BULLETIN

Bulletin No. 105

SUBJECT: MODEL PA-12 BATTERY HOLD-DOWN AND FUSE BLOCK

BATTERY BOX COVER ASSEMBLY

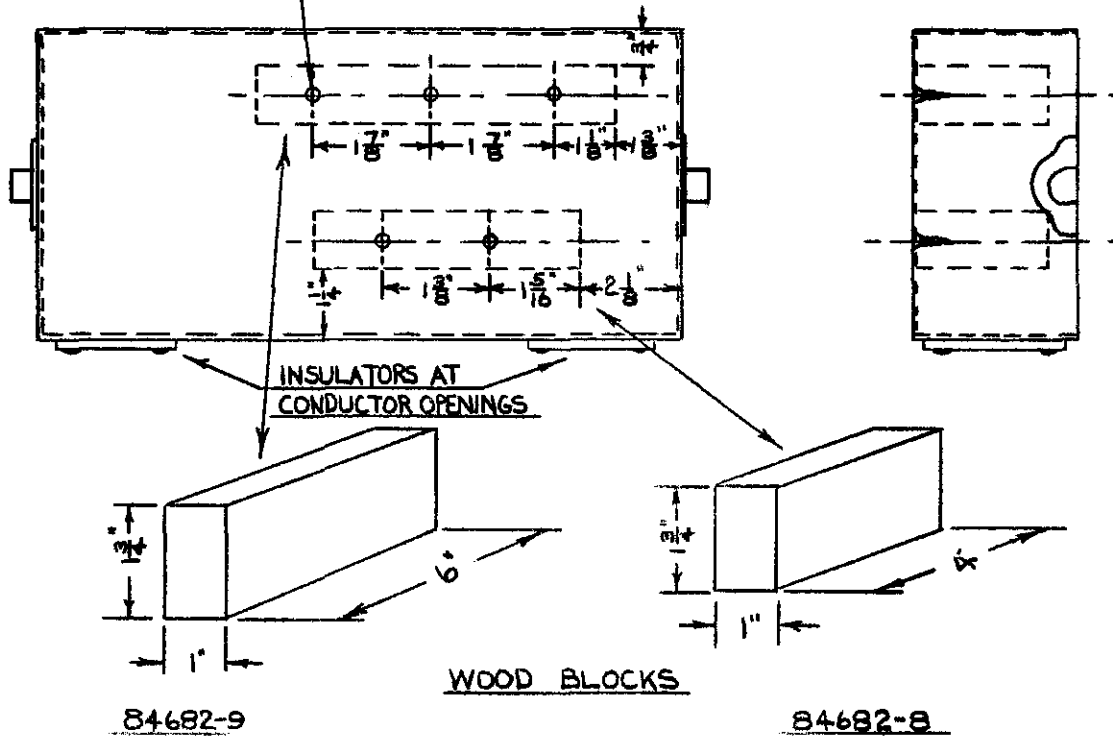
On early model PA-12 airplanes the BATTERY HOLD-DOWN, when provided, consists of a metal bracket with fibre insulation at its lower end.

Reports have been received that the insulation in some cases has deteriorated, allowing the bracket to contact the battery terminals causing a short circuit.

To avoid the possibility of this occurring, we recommend that on all airplanes listed above, wooden blocks be installed as shown on the sketch on reverse side this bulletin.

These parts, numbers 84682-09 and 84682-08, one each required, are available through your local Piper Distributor or Dealer, at cost.

1/13 HOLE IN COVER
*4 WOOD SCREW, 5 REQ.

FUSE BLOCK ASSEMBLY

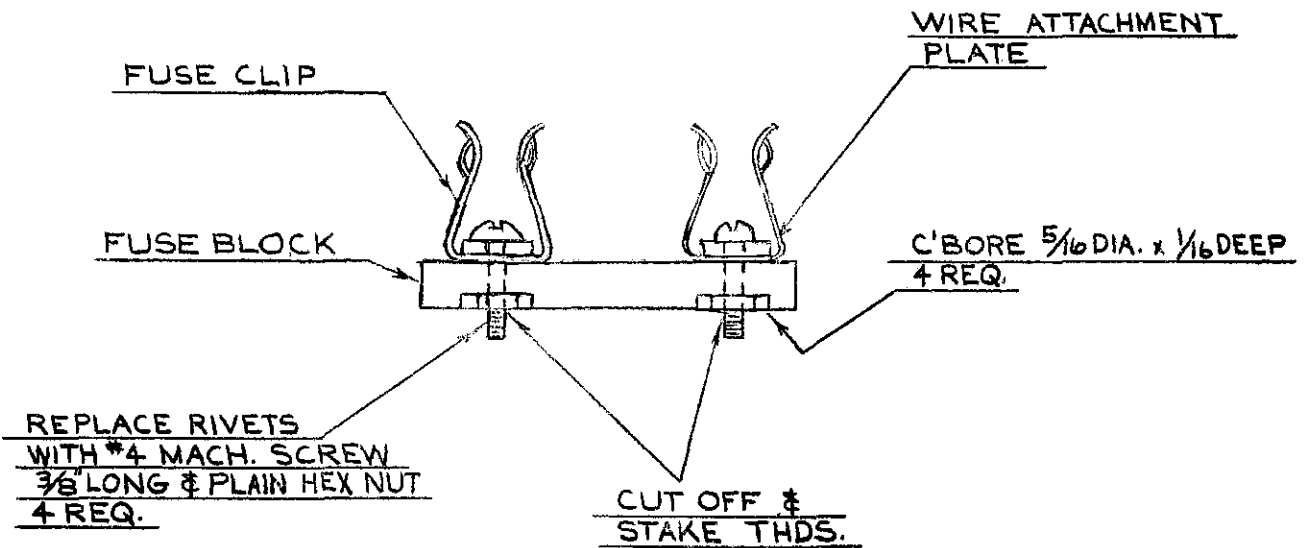
Reports have been received of arcing occurring between the fuse-clip and the wire attachment plate on the fuse block. These parts are held in contact by a rivet, which in some cases becomes loosened. As the arcing may cause premature fuse failure, we recommend the fuse block be removed from the airplane and revised as shown on sketch on reverse side this bulletin, or replaced with reworked part.

After removing fuse block from plane, the reworking may be done as follows:

1. Punch out clip attaching rivets.
2. Counter bore fibre block 5/16 dia. x 1/16 at rivet holes. (Continued)

3. Re-assemble using #4 machine screws and plain hex nuts in place of rivets.
4. Cut off excess screw length.
5. Stake threads (support screw head while staking).

New fuse blocks, of the reworked type, Part No. 11718-00, one required, are available through your local Piper distributor or dealer, at cost.
